PUBLIC IMPROVEMENT CONSTRUCTION PLANS
THE BRICKYARD - PRAIRIE HAWK INFRASTRUCTURE
A PARCEL OF LAND BEING A PORTION OF THE NORTHEAST 1/4 OF SECTION 10 AND THE NORTHWEST 1/4 OF SECTION 11 TOWNSHIP 8 SOUTH, RANGE 67 WEST OF THE 6TH P.M. TOWN OF CASTLE ROCK, COUNTY OF DOUGLAS, STATE OF COLORADO.
TOWN OF CASTLE ROCK PROJECT NO. CD25-0042

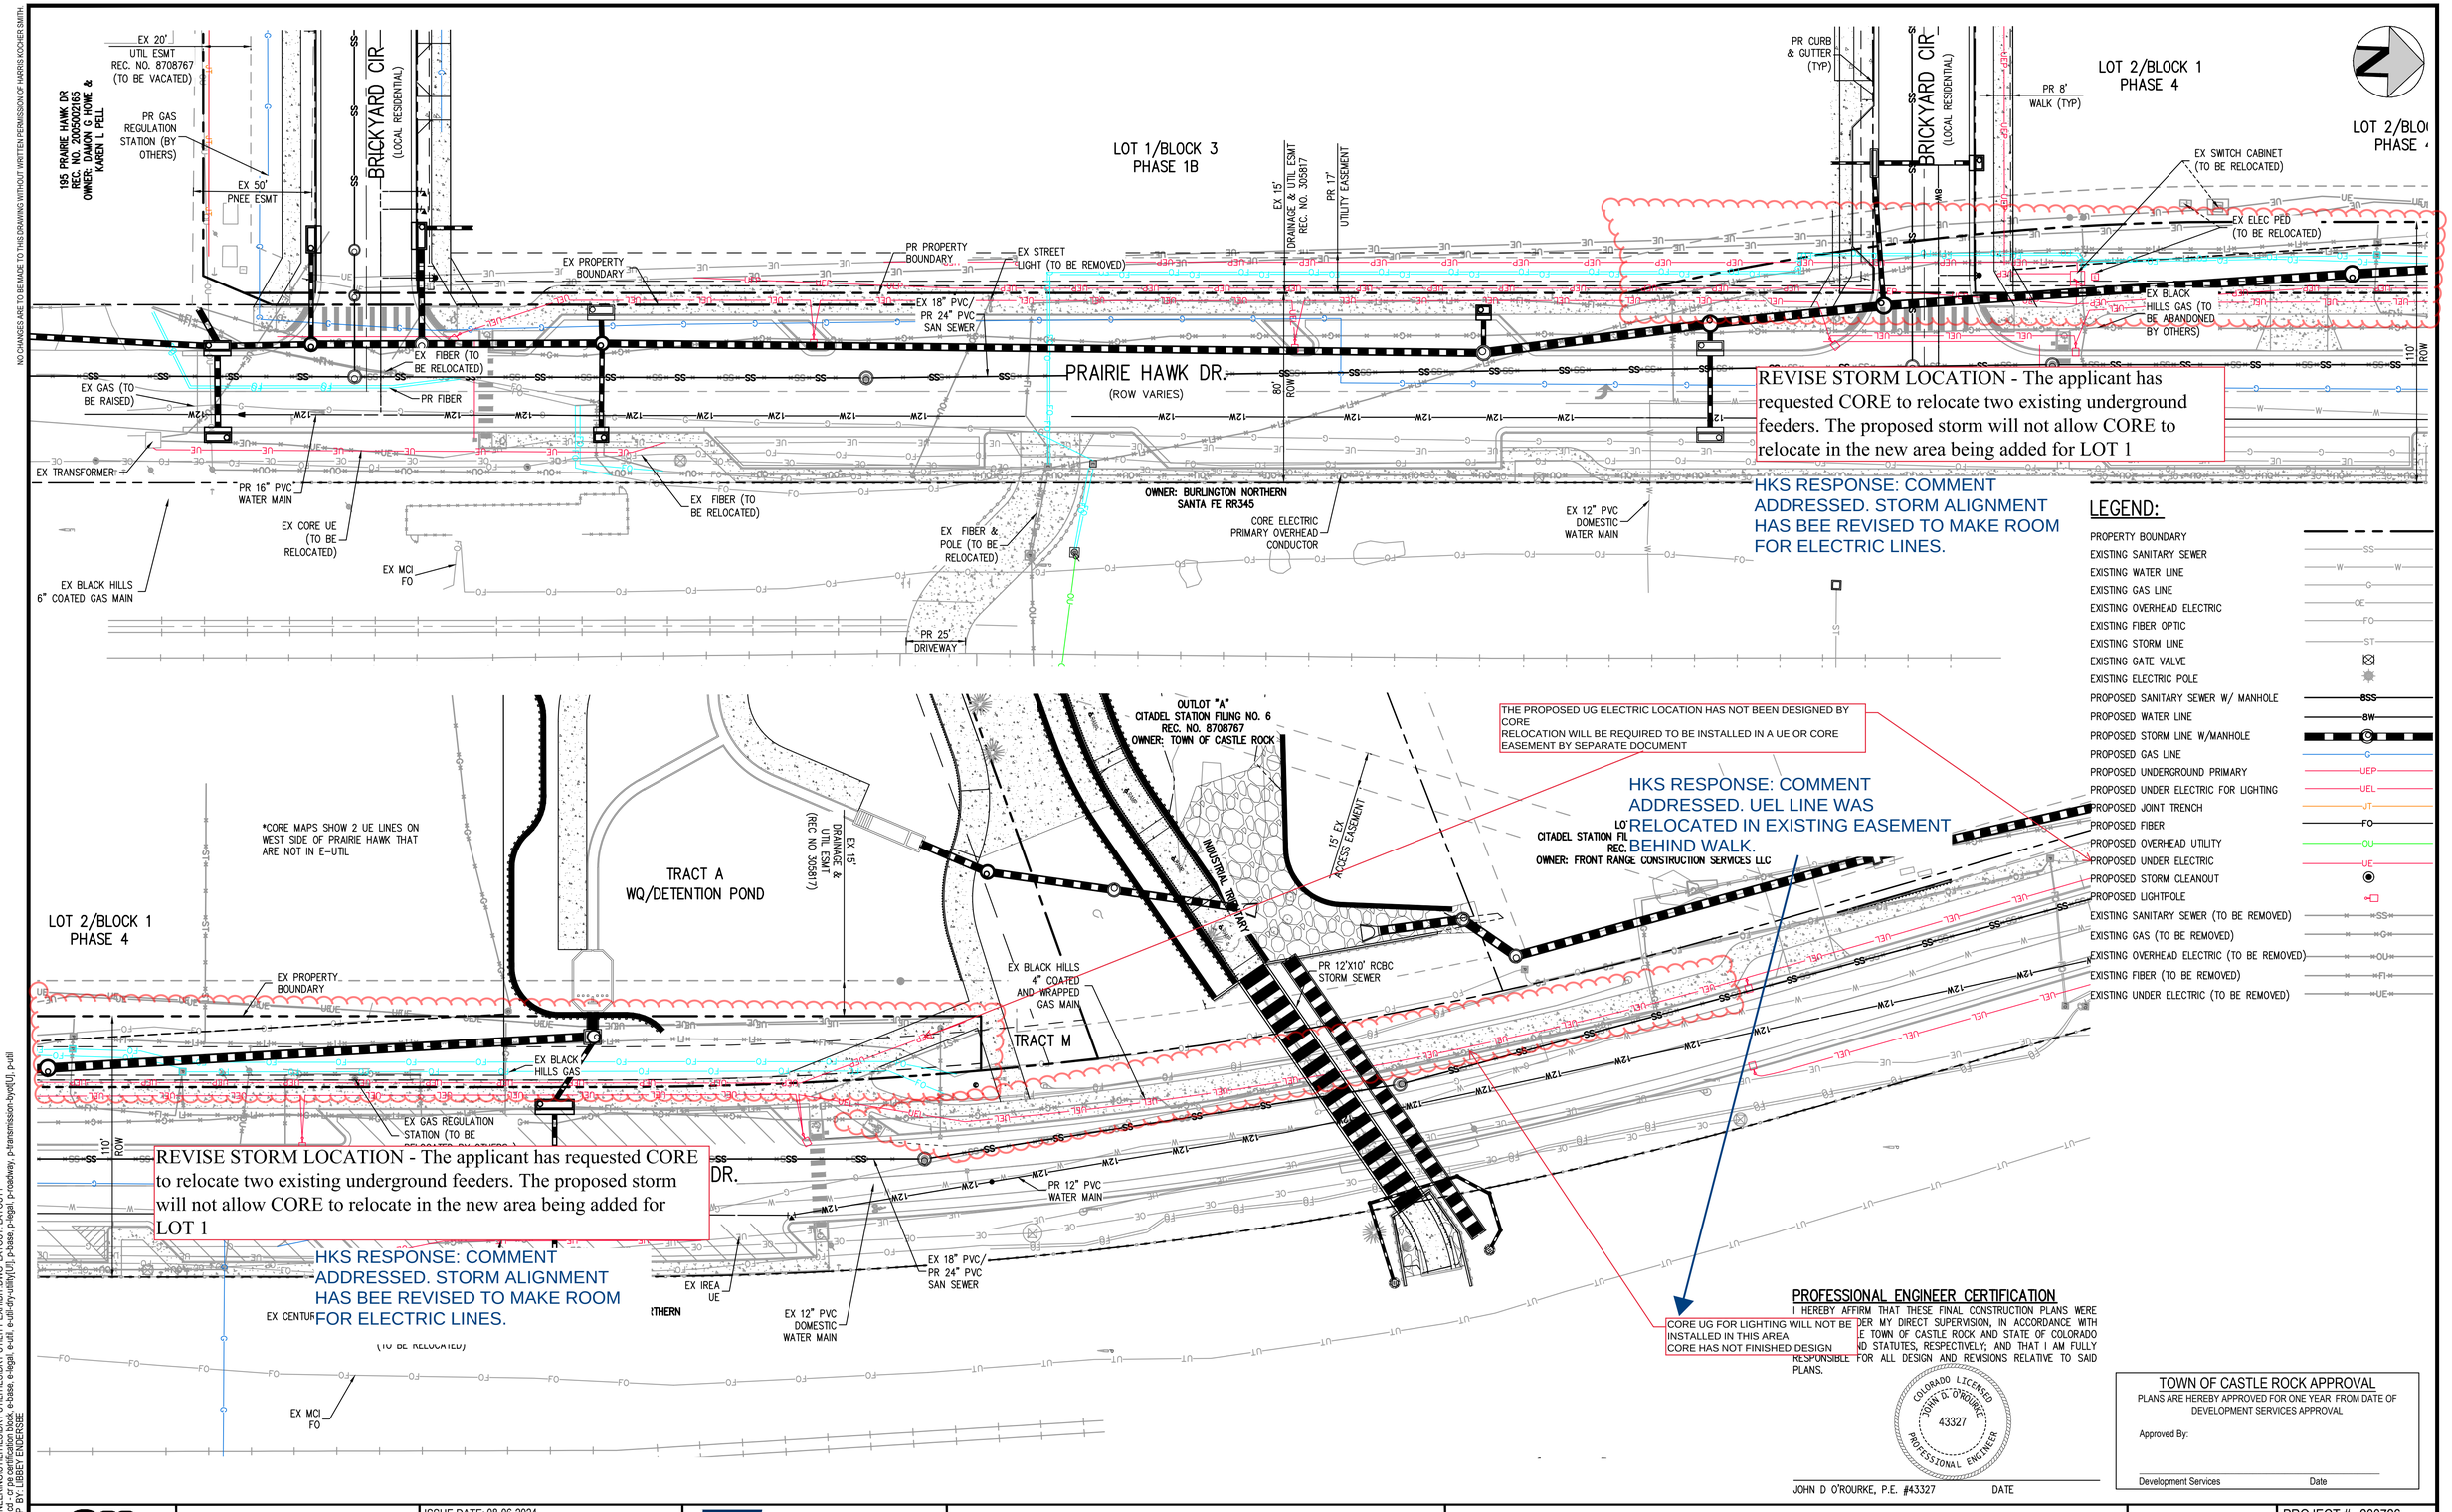
REVISE STORM LOCATION - The applicant has requested CORE to relocate two existing underground feeders. The proposed storm will not allow CORE to relocate in the new area being added for LOT 1

HKS RESPONSE: COMMENT ADDRESSED. STORM ALIGNMENT HAS BEE REVISED TO MAKE ROOM FOR ELECTRIC LINES.
